memorandum

TO	Tim Carter	FROM	Tom Garden
	Carter Group Limited	DATE	18/11/2025
RE	104 Ryans Road Fast Track Application – Response to ECan Groundwater Comments

Figure 4: Groundwater level measurements and associated piezometric contours (extrapolated across the site) from July 2013 high groundwater level event.

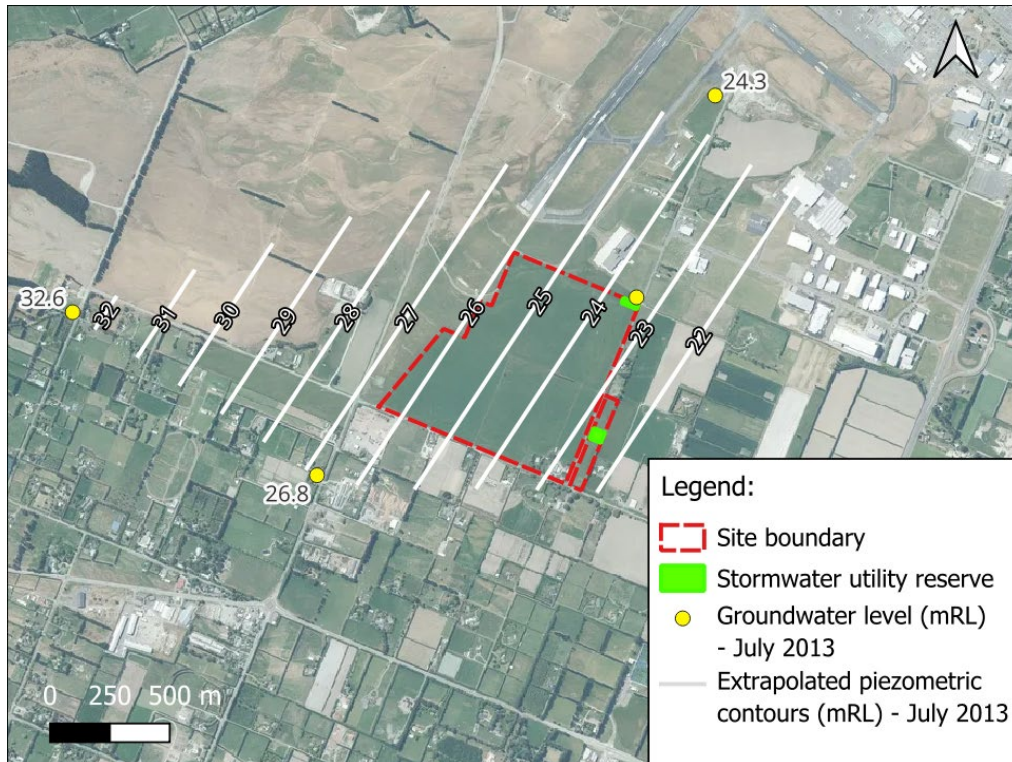
The comments from Marta Scott (ECan) indicate a concern that the highest possible groundwater levels at the site could be higher than estimated in the Pattle Delamore Partners (PDP) Assessment of Groundwater Effects, which may have implications regarding potential for contamination of downgradient drinking water supply bores from soak pits that are proposed to be used for infiltration of stormwater. As recommended by ECan, a more detailed assessment of groundwater levels has been undertaken.

The groundwater levels from the three ECan monitoring in July 2013 were contoured to create a piezometric contour map of peak groundwater levels. The contours were extrapolated across the site, assuming the same hydraulic gradient continued beneath the site. The resulting contours are shown in Figure 4. The piezometric contours were used to create a map of estimated depth to peak groundwater levels, by subtracting the piezometric surface elevation from the LiDAR digital elevation model (DEM). The depth to groundwater map is shown in Figure 5.

Figure 5: Estimated depth to groundwater across the site at the time of the July 2013 high groundwater level event.

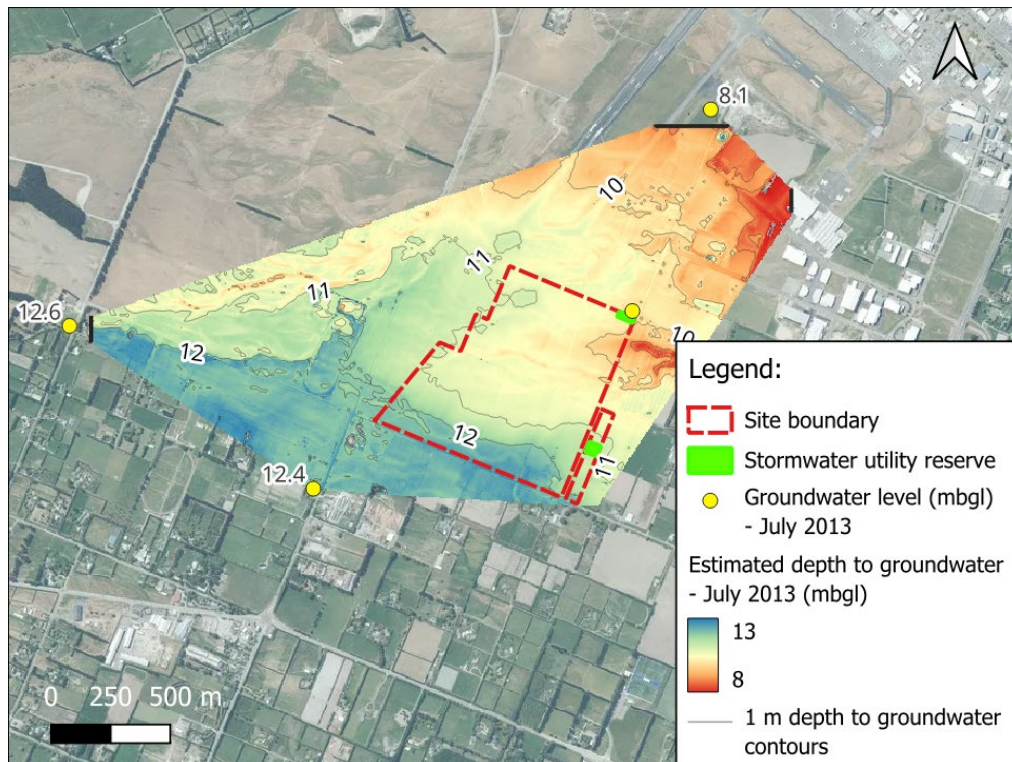
Marta Scott recommended that a more detailed survey of land surface and groundwater levels be conducted to inform a map of highest groundwater levels across the site. In response PDP has conducted such a survey, as detailed in Section 2.0. Potential implications regarding potential for contamination of downgradient drinking water supply bores from soak pits are assessed in Section 3.0.

The depth to groundwater map shows that the estimated highest groundwater levels (based on the July 2013 event) range from approximately 9.2 to 12.9 mbgl, with a mean of 11.0 mbgl. The depth to groundwater at the proposed Northern Stormwater Management Area (SMA) is estimated at 10.18 mbgl, and 11.3 mbgl at the Southern SMA.

Figure 6: Layout of south-eastern side of site, showing location of southern SMA and soak pits and nearest domestic supply bore M35/9627.

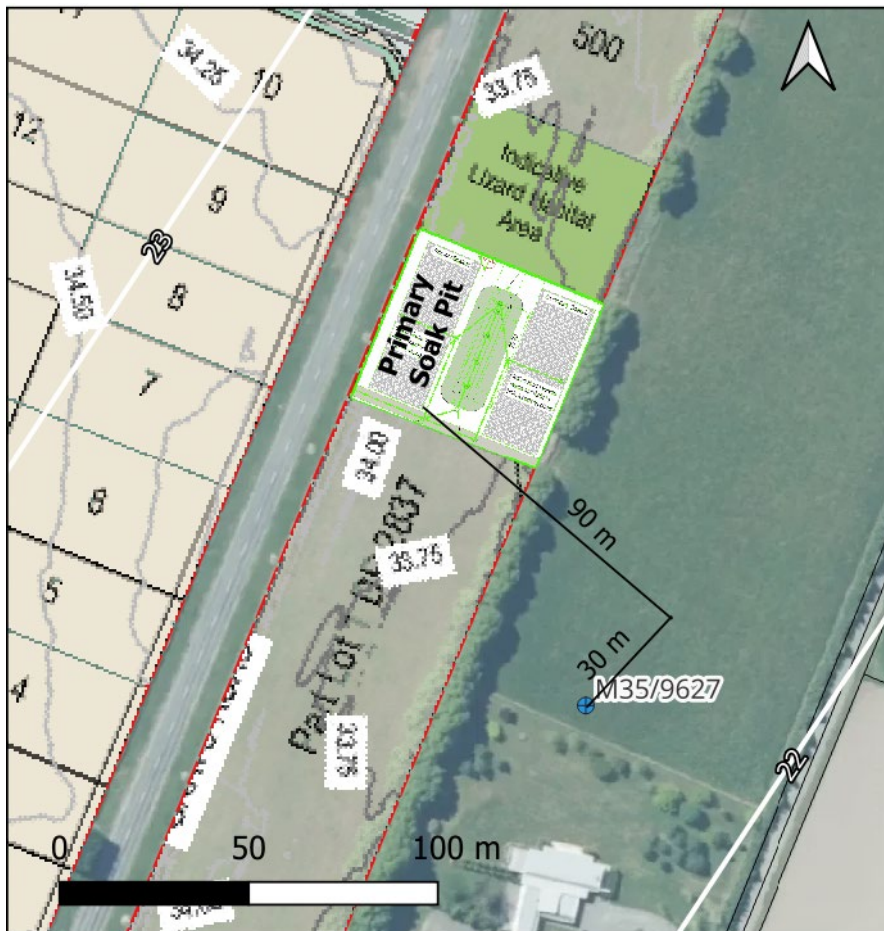
The ECan review indicated that there is concern regarding potential contamination of downgradient drinking water supplies due to contamination from stormwater, with *E. coli* and Norovirus potential contaminants of concern modelled using the Microbial Risk Assessment (MRA) tool developed by ESR.

The *E. coli* contamination risk was re-modelled using the MRA tool and the actual distance from the southern SMA and primary soak pit (which is closest to a domestic supply bore) and a revised vadose zone depth of 1 m (the tool allows only whole numbers for vadose zone depth), based on the results in Table 2. Based on the site layout shown in Figure 6, a downgradient distance of 90 m and a cross-gradient distance of 30 m was used to the nearest supply bore M35/9627. All other parameters were kept the same as the previous PDP assessment. The result indicates a probability of exceeding the maximum acceptable concentration of 0%.

If the vadose zone is decreased to zero, then the tool estimates a probability of exceeding the maximum acceptable concentration of 11%. Considering the highly conservative nature of the assessment, and the very low chance that maximum mounding during a 2% 50-year event would occur concurrently with highest historical groundwater levels, it is considered that this risk is acceptable, and in reality the risk of *E. coli* contamination to downgradient water supplies is considered negligible.
